# MISSOURI 2019 AIRPORT LIGHTING PACKAGE

## EAST PACKAGE

### ADDENDUM NO. 1

November 2, 2020

1	N: 760279.17 E: 797517.95
2	N: 760289.70 E: 797509.49
3	N: 760292.52 E: 797513.00
4	N: 760281.99 E: 797521.45

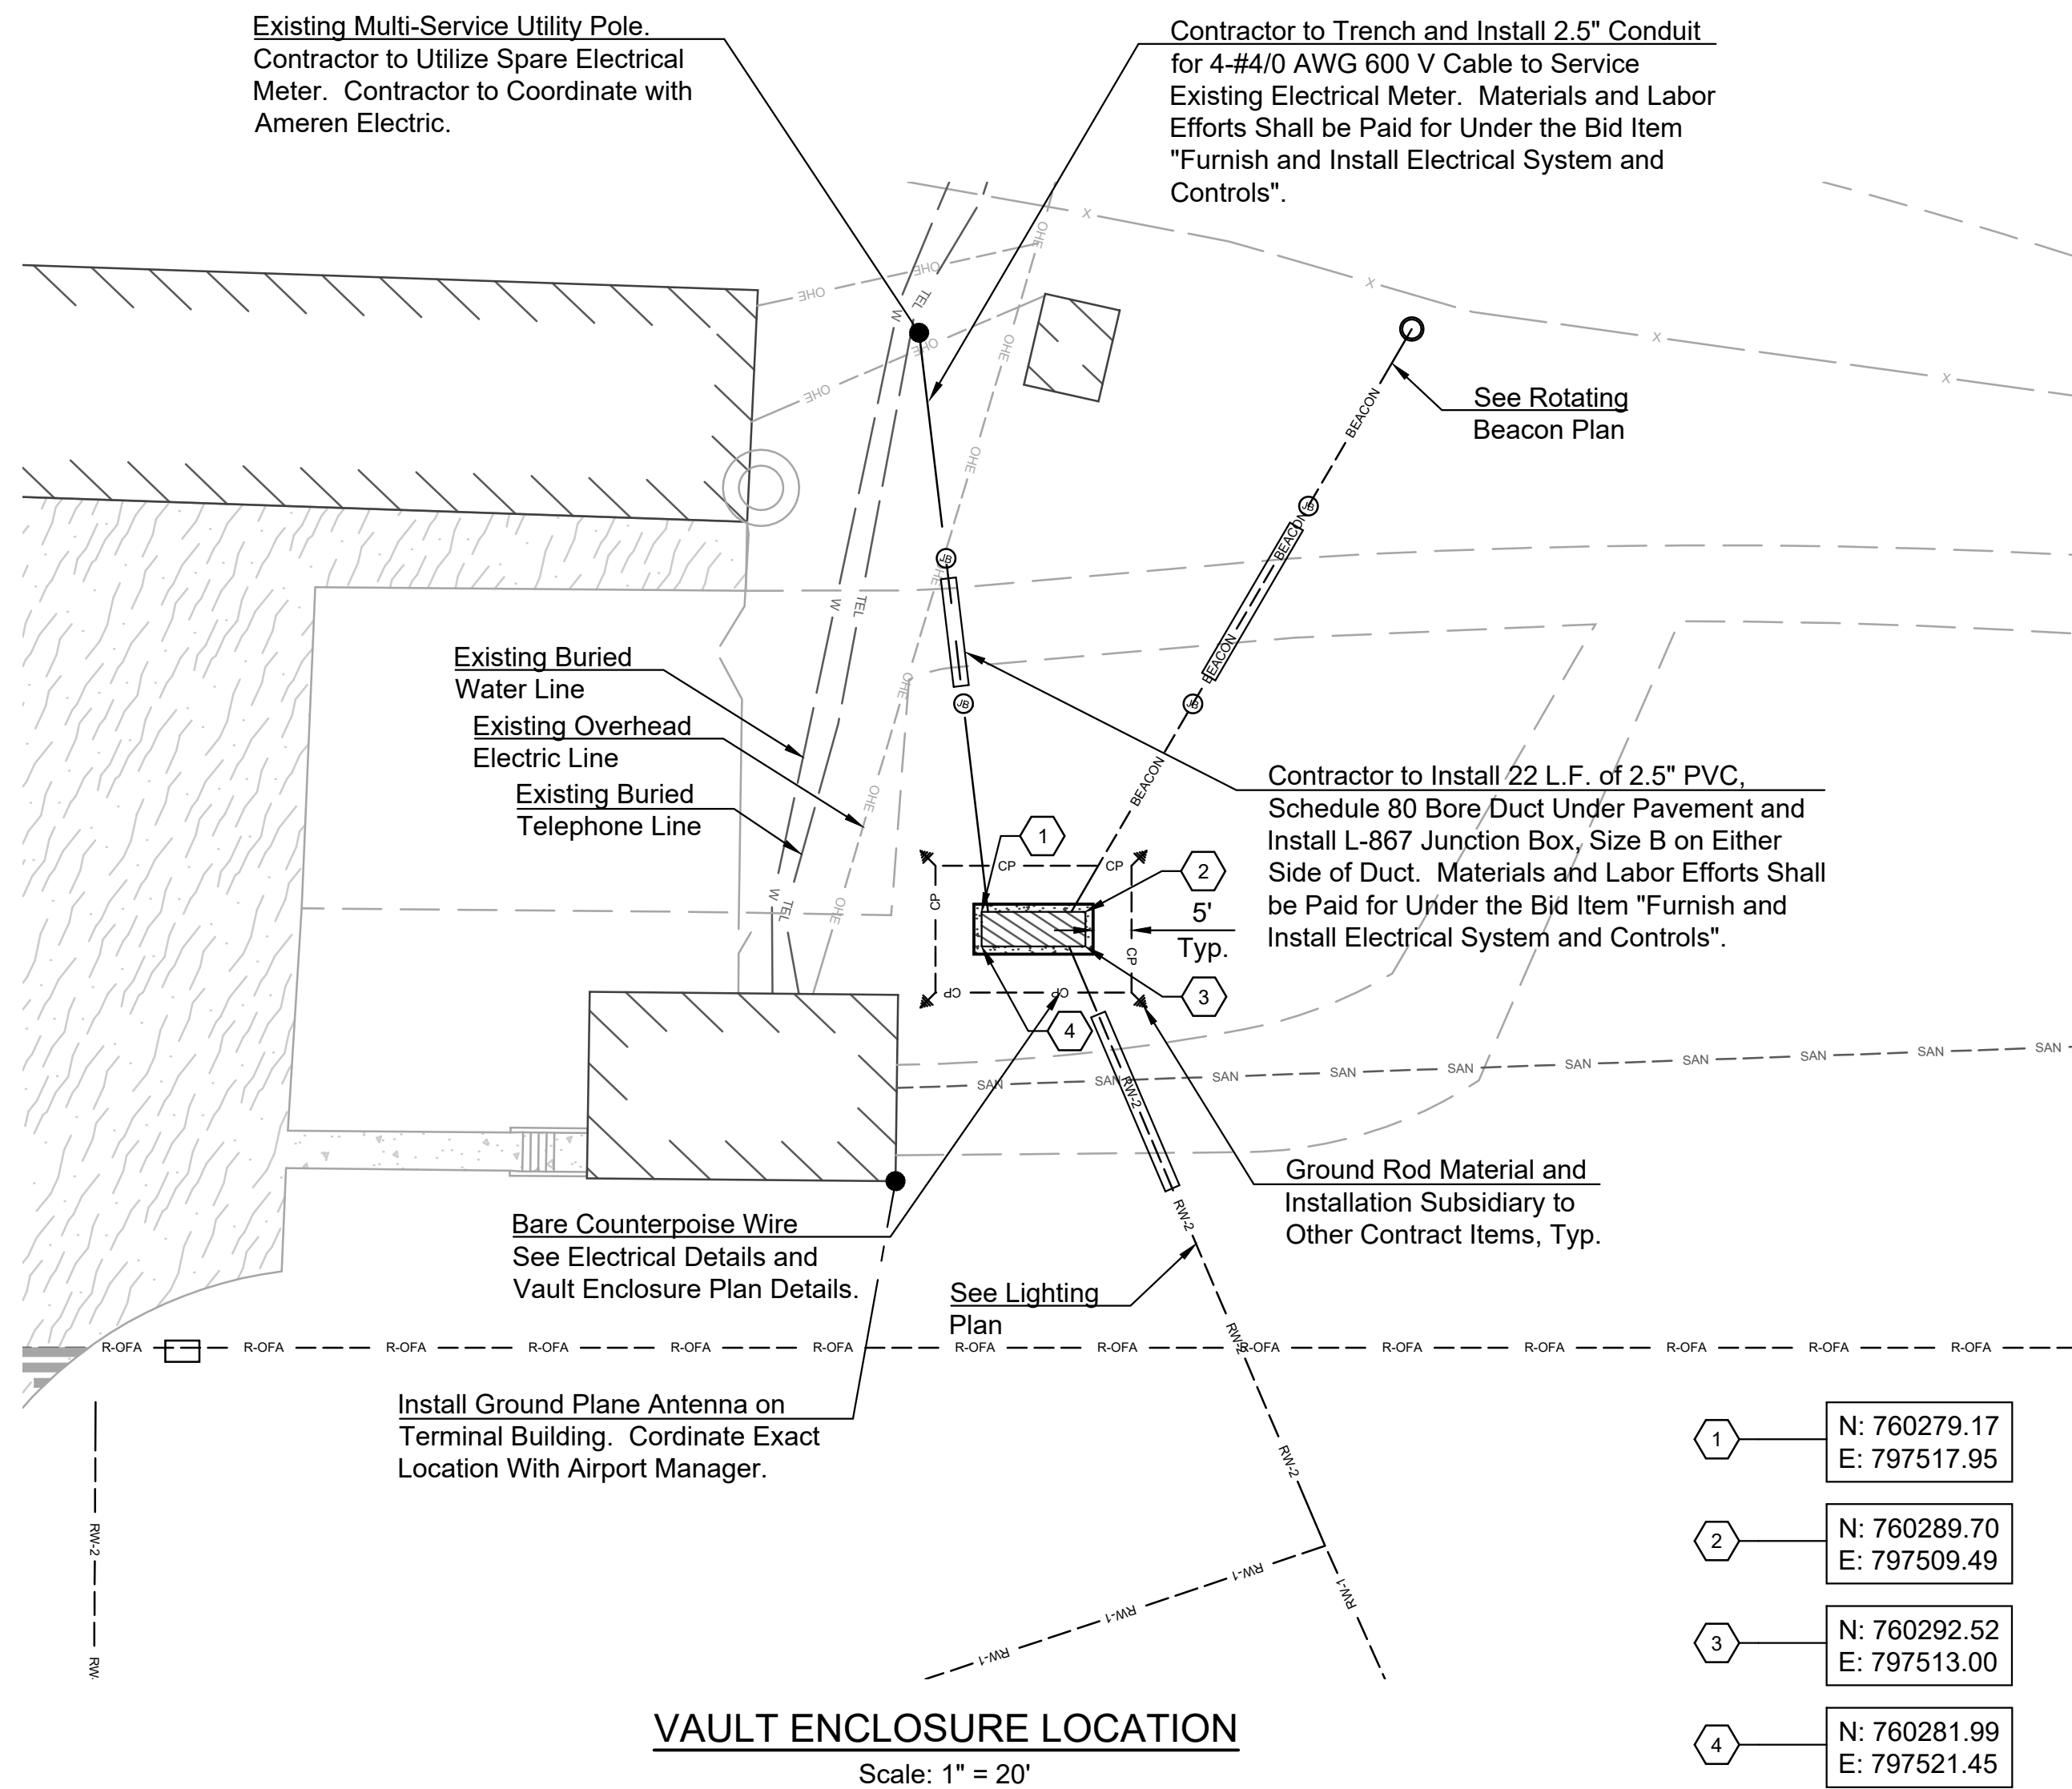
1. **Schedule A: Captain Ben Smith Airfield**, Sheet No. 16 Vault Enclosure Plan and Details. The 8' x 8' wireway is now a 4" x 4" wireway. The 100A lighting contactor for the regulator and wind cone was removed. The regulator will now be controlled via a 120V, 5A (minimum) control relay and the wind cone via a 20A, 2 pole lighting contactor. The PAPI control relay is now a 20A, 2 pole lighting contactor.

VAULT ENCLOSURE  
PLAN AND DETAILS

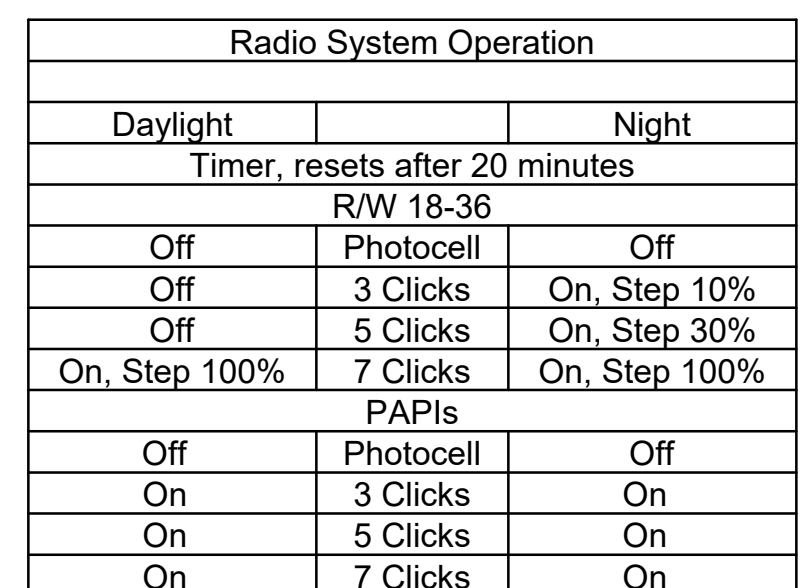
3. **Schedule B: Bonne Terre Municipal Airport**, Sheet No. 12 Vault Enclosure Plan and Details. The vault height (6'-10" minimum) and length (13'-6" minimum) were added to the vault enclosure elevation detail. The 8" x 8" wireway is now a 4" x 4" wireway. There is now a 120V, 5A (minimum) control relay and 20A lighting contactor located within the vault enclosure replacing the 100A, 5 pole lighting contactor.
